ADDENDUM # 04

RFQ NO. CW29854

SHN Mental Health Inpatient Consolidation Pod 3A

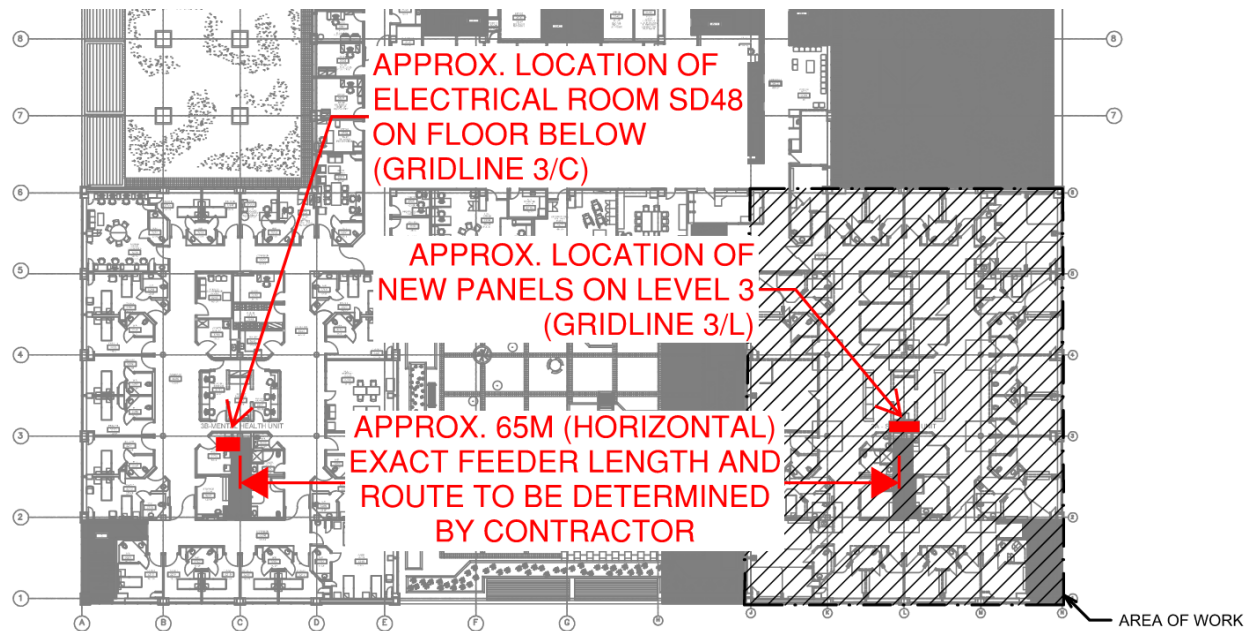
With addendum E-02 , we have received the revised drawing E0-00 with floor plan for location of room SD48 from SD level which is non-scale plan and hence please provide length of the new feeders from panels PP-SD-B-AA & PP-SD-B-

EAA to LP-3D-EA, LP-3D-EB, LP-3D-A & LP-3D-B panels to include them in our quote.

Exact length cannot be provided as feeder routing must be determined by the awarded contractor. However, please see below additional information:
